Document Control	
Document Type	Highway Response 2
Site Location	Alexandra Stone Works LE6 6LE
Proposed Development	Padel Courts
Client	Pulse Padel
Planning Reference	26/00359/FUL
Status	Planning Application – Consultation Response
Date	10/07/26
Written By	JA
Checked By	CS

This Highway Response (HR2) has been produced to address the comments raised by Leicestershire County Council (LCC), the Local Highway Authority (LHA), in its consultation response (Ref: 2026/0359/H/R1) dated 08-07-26.

Figure 5 – Desford Lane Vehicle Speed Surveys (LCC NDI, 2026)

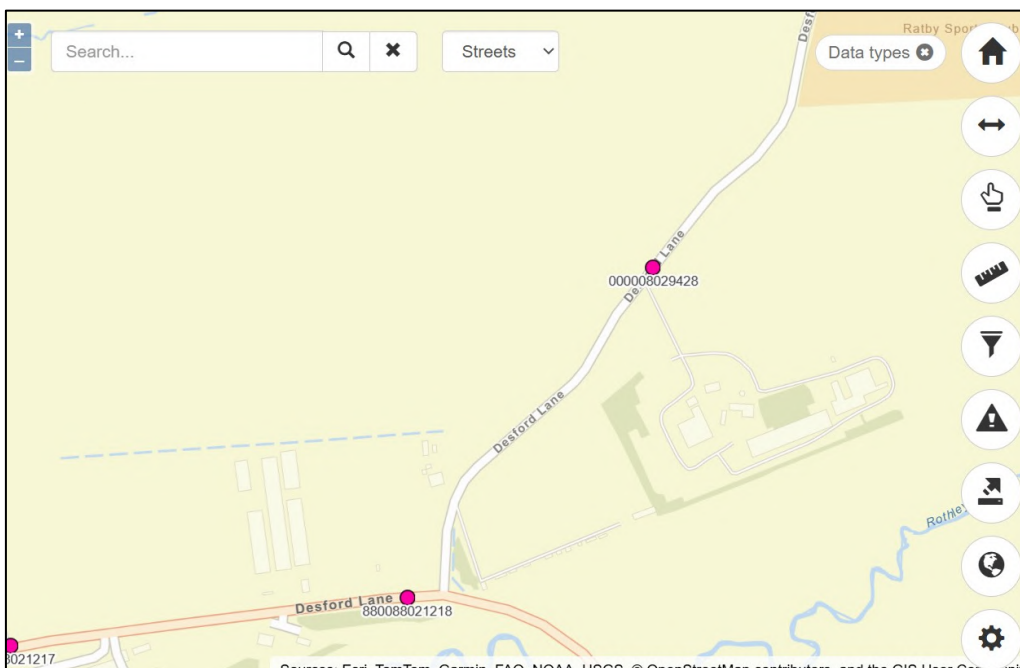
"The LHA therefore maintain that the Applicant should undertake a speed survey to demonstrate appropriate visibility can be achieved at the existing access, and that it is safe and suitable for an intensification in use."

Given that the local highway network is subject to highway works as a result of 21/01295/OUT, with evidence that works have already taken place and residential dwellings are currently under construction based on Google Street View, then undertaking new speed surveys on Desford Lane is unlikely to be representative of typical driver behaviour on the road. Subsequently, Exigo have requested existing vehicle speed data on Desford Lane from LCC using the provided email address. The NDI team have confirmed that there is an existing vehicle speed survey near the existing site access (ref: 000008029428 – see Figure below) from September 2021 (20/07/26 – 28/07/26).

If deemed necessary, Exigo can obtain the historic speed data from NDI to check compliance with the current visibility assessment. As aforementioned, given current and planned changes (S278 / S38 / TRO) to Desford Lane as a result of planning permission 21/01295/OUT, new speed surveys are unlikely to reflect actual highway conditions and therefore using historic data it is considered entirely robust for assessing the current site access layout and visibility requirements. The current assessment is based on speed data from 2021 and 2022 as provided in the AHA TA accompanying planning permission 21/01295/OUT.

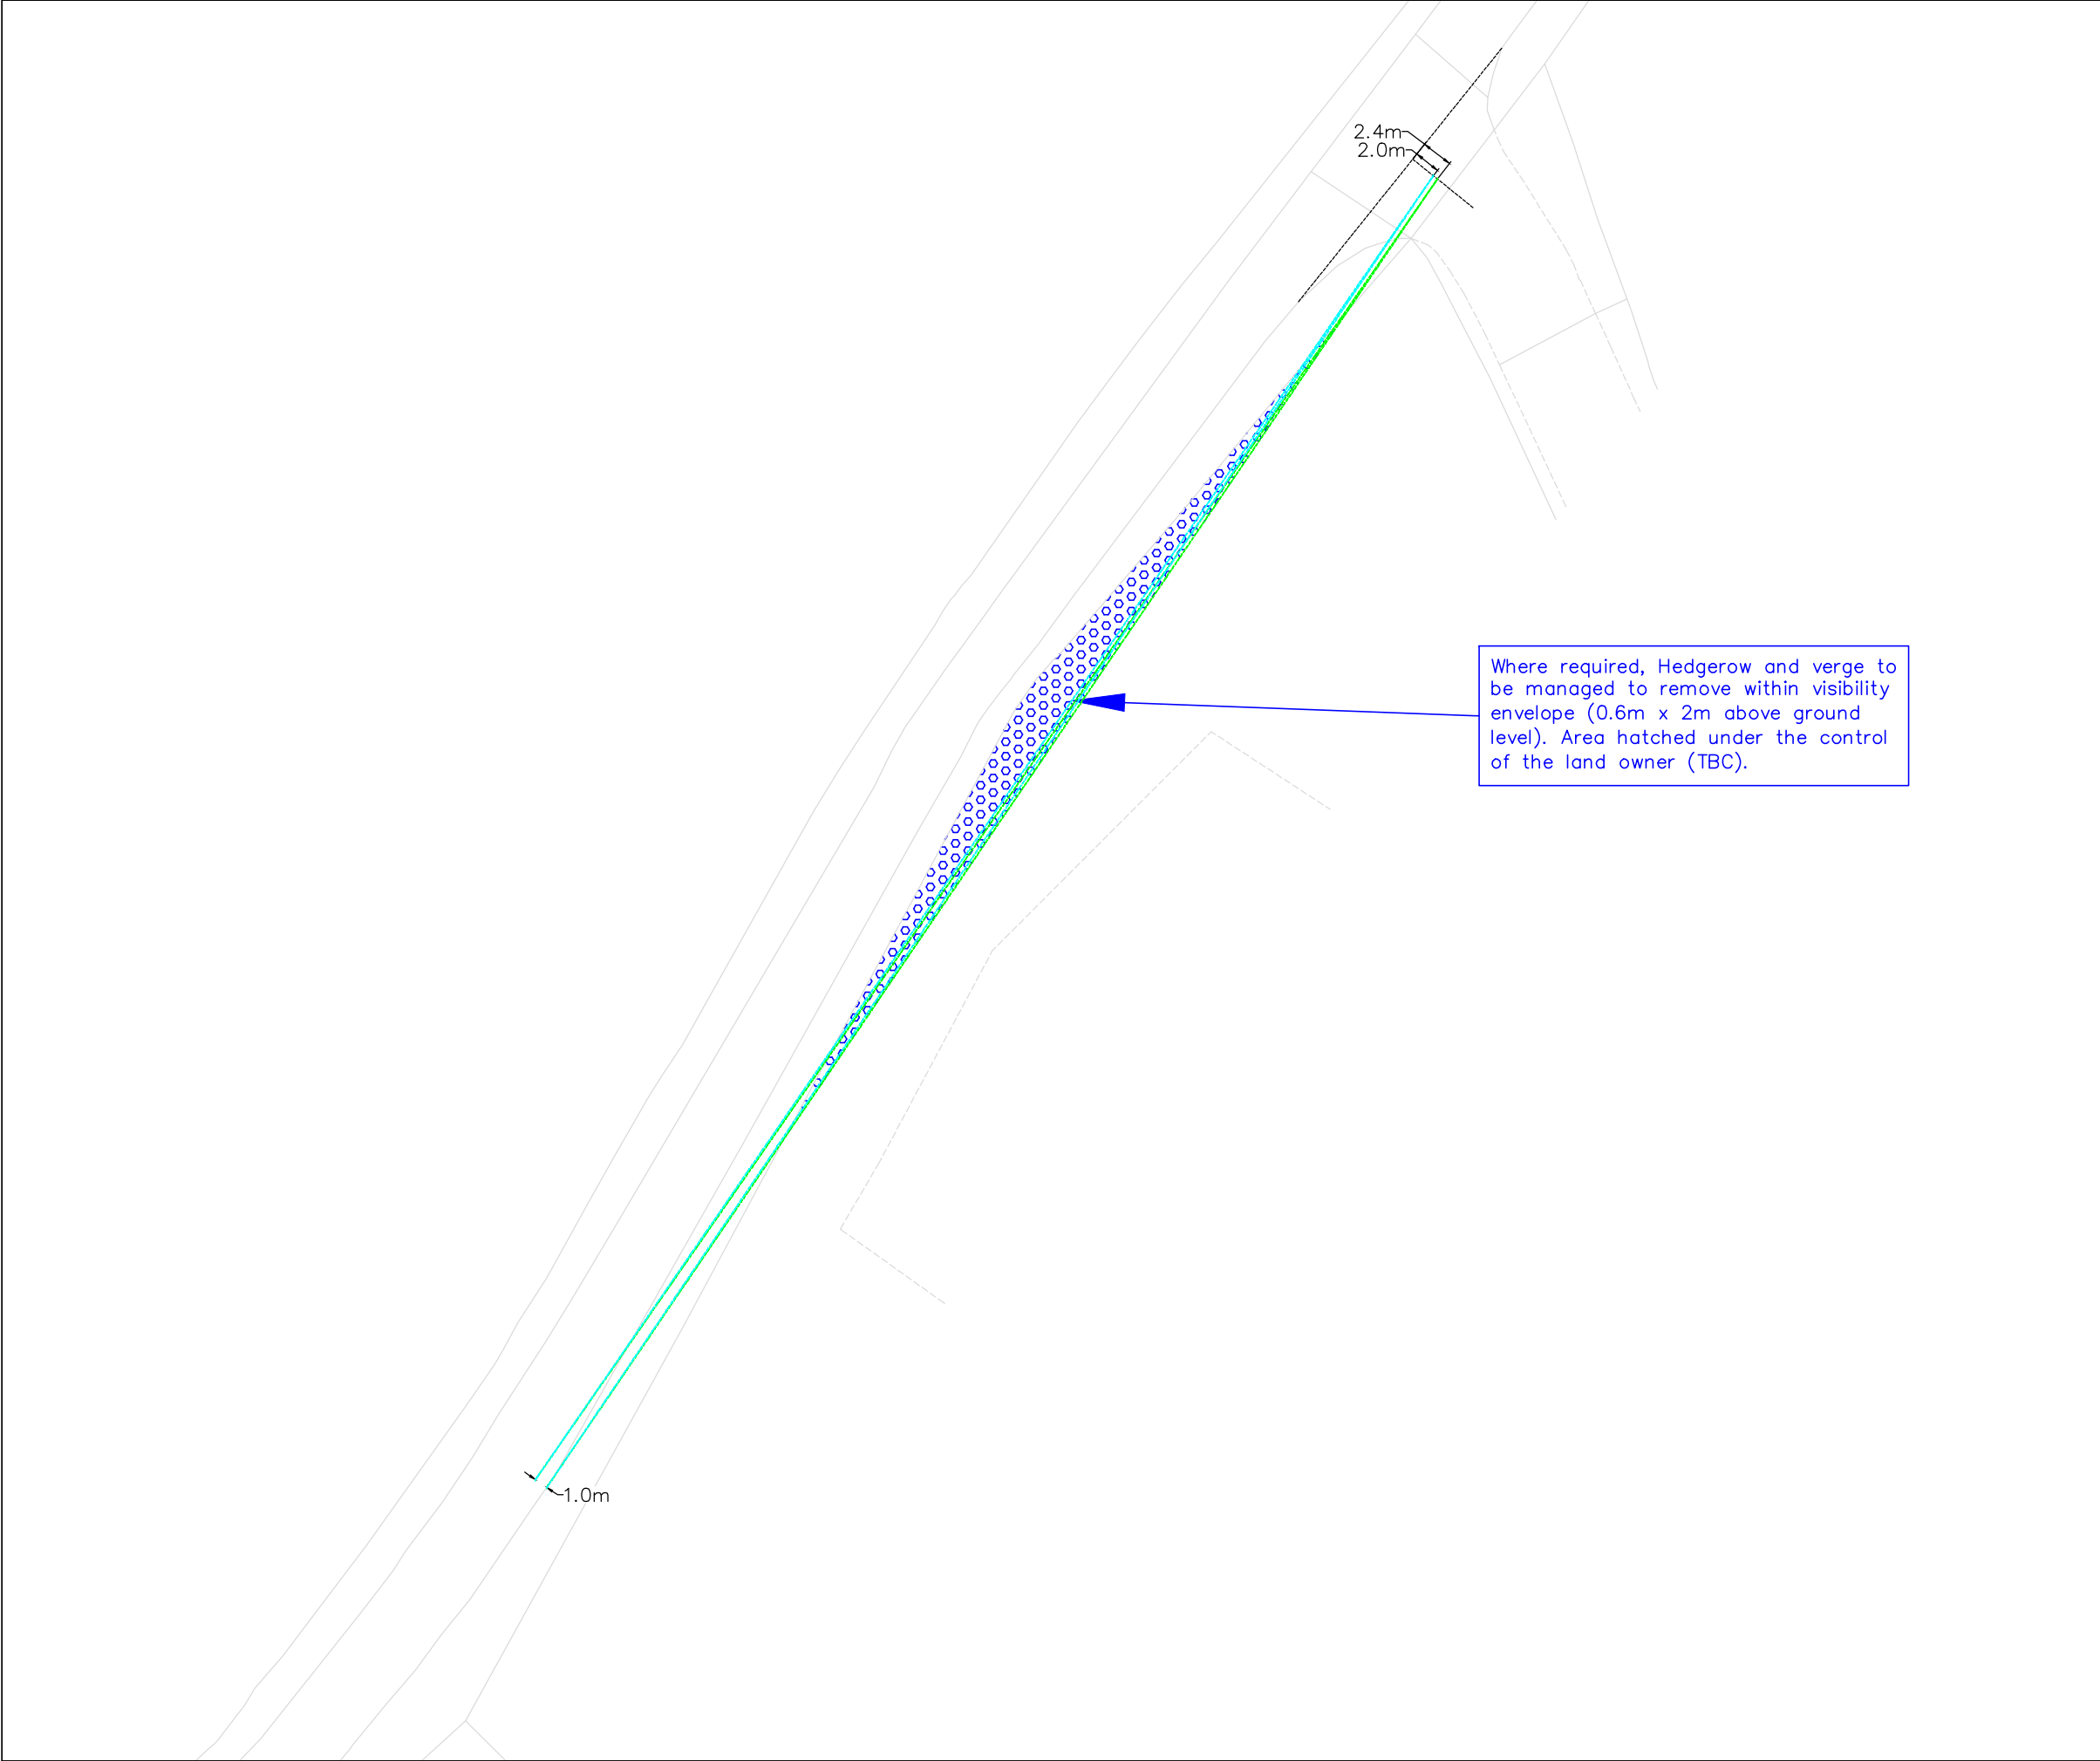
"Notwithstanding the Applicants conclusion, the LHA advises the proposals could generate up to 16 additional two-way vehicle trips per hour based on two arrivals and two departures per padel court and all padel courts being occupied. This represents a considerable amount of additional traffic throughout the day which would be turning at a junction whereby visibility is below the 215m stated within Table 6 of the Leicestershire Highway Design Guide for a road subject to the national speed limit and where measured 85th percentile speeds are between 54 mph to 62 mph."

Whilst we disagree that a worst-case increase of less than 30 no. 2-way trips per hour can be classified as a significant intensification, the achievable visibility at the existing site access junction has been demonstrated on the attached drawing.

The existing speed surveys within the vicinity of the site demonstrate that recorded 85%ile vehicle speeds are significantly below the maximum permitted on the road. In line with Table 6 of the Leicestershire Highway Design Guide a minimum Stopping Sight Distance of 120m would be required based on the recorded 85%ile vehicle speeds on Desford Lane. Drawings showing the 120m visibility splay at the access junction has been appended to this document, showing the achievable visibility splay in both directions.

In order to achieve the full 120m visibility in both directions, the existing verge and hedgerow would need to be trimmed back within the vertical visibility of envelope of between 0.6m and 2m from ground level. For the visibility splay to the north, based on Google Street View imagery from April 2026, the hedgerow along the boundary of the adjacent site has already been removed (see Figure 3), leaving only the extent at the corner of the application site which is under the control of the landowner or within the adopted highway.

For the visibility splay to the south, based on Google Street View imagery from April 2026, the vegetation along the boundary of the application site has already been removed (see Figure 4) and formed into a bank. In any case, the actual visibility at the site access can be checked on site with manual measurements, and the bank adjusted where required.

As demonstrated above and in the appended drawings, the existing site access achieves the minimum visibility requirement for the previously recorded and agreed 85thile vehicle speeds on Desford Lane, with only minor amendments required to existing vegetation / boundary treatment with the landowners or LHA's control.
